**Re: Main River Culvert Condition Technical Note for proposed Conversion at 31 Chapel Hill, Linthwaite**

We write in response to your planning consultee response of 13<sup>th</sup> June 2023 ref RA/2023/145899/01-L01 to William Simcock of Kirklees Metropolitan Borough Council.

**Project:**  
 Refurbishment of  
 Former Methodist  
 Chapel to create  
 9 Apartments.

**Drawing:**  
 Proposed  
 Site Plan

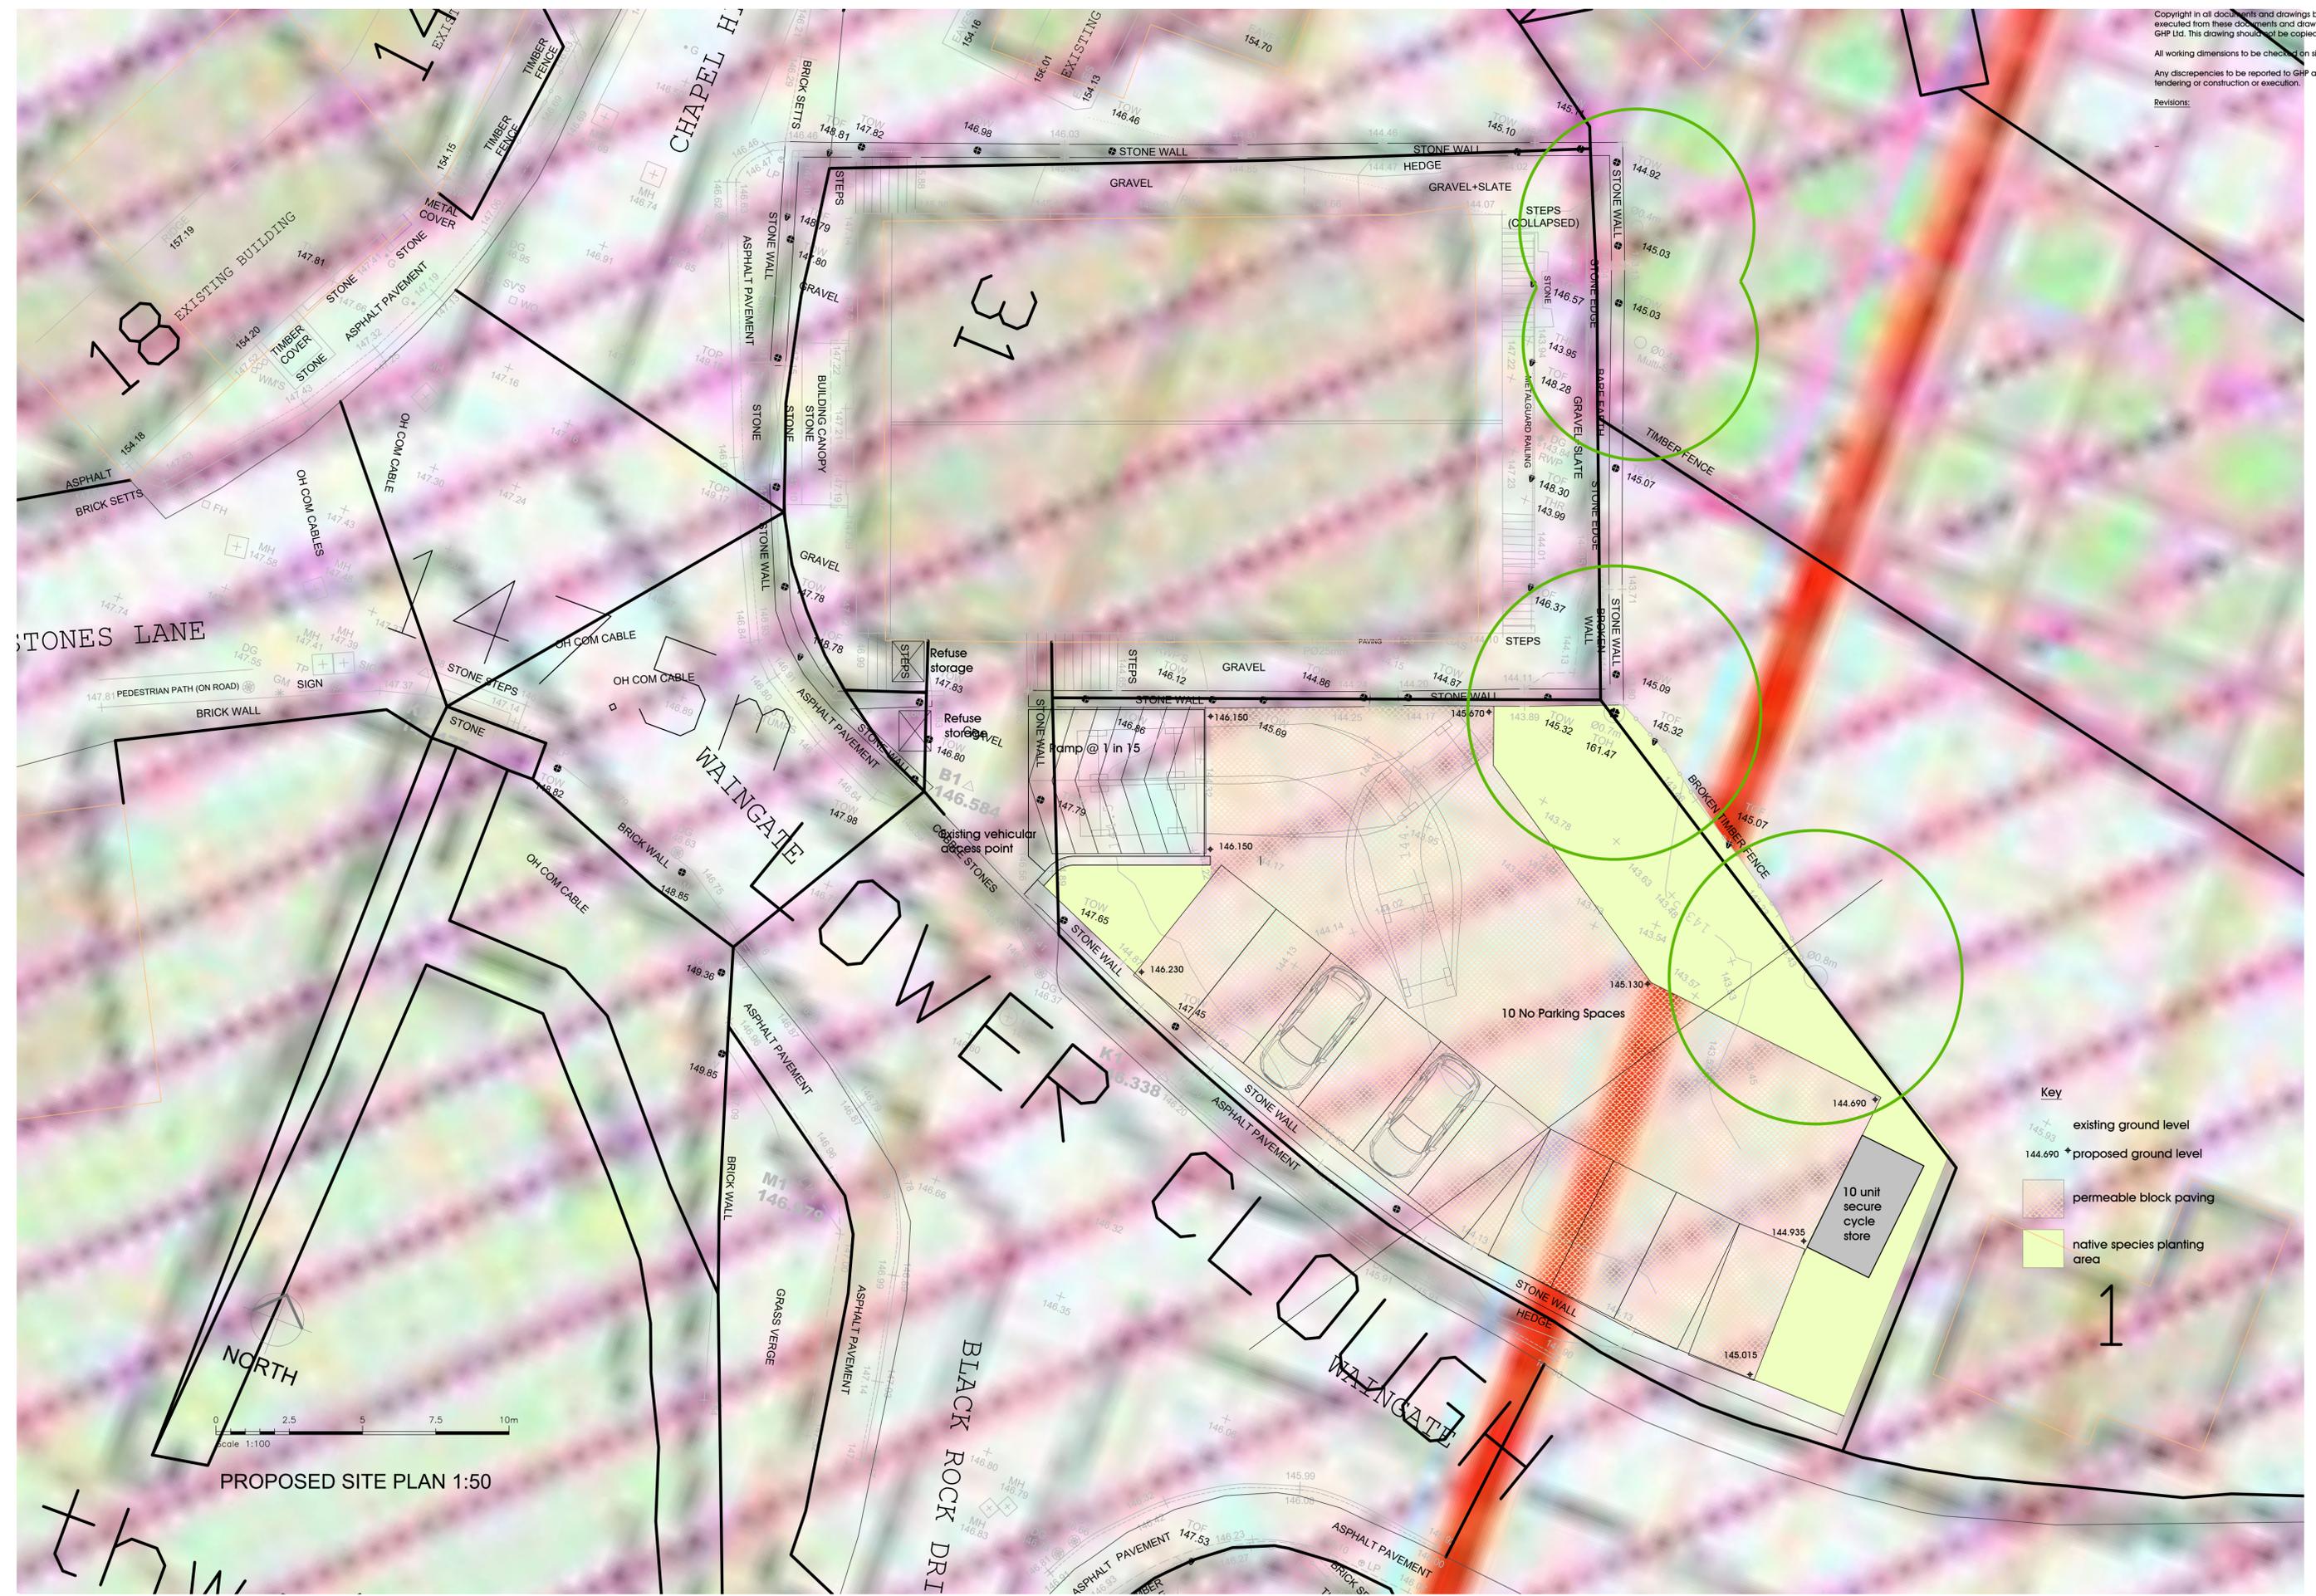
GHP Architects have provided a site plan which indicates the position and alignment of the culvert. Beyond this, a visual inspection of the culvert has been undertaken and photos are shown below (video is available if considered of benefit).

From review of the GHP site plan and wider aerial imagery, it can be seen that the culverted watercourse passes beneath the adopted highway 'Waingate' and continues to be culverted north of this point, for approx 130m overall. The culvert runs beneath the proposed development site and numerous other parcels of third-party land (assuming that the various properties to the North, accessed off Chapel Hill are all privately owned). We note that on this route there are other areas of private driveways and apparent garages over/adjacent to the culvert.

- From visual inspection, the culvert appears in reasonable condition, with no indication of defects or deterioration (stone arch construction).
- The loading applied to the culvert from an adopted highway is far in excess of the loading from a private car parking area for residential dwellings. In addition to this the access space will prohibit any larger vehicles from accessing this area.

- The culvert runs beneath an adopted highway and numerous other private curtilages. As such, it is extremely unlikely that the entire section of culvert would ever be opened up. In conjunction with this, given the short length in question beneath our development site, there is very limited benefit to be gained from opening up the culvert in this situation.

- The area of land over the culvert is proposed to be a small residential car parking area. Due to the space available, large machinery cannot be used to form the proposed hardstanding, i.e. very unlikely to overload the culvert. In addition to this, the proposed car park finish is to be macadam, which would not pose any difficulties in excavation, should culvert maintenance works be required at some point in the future.
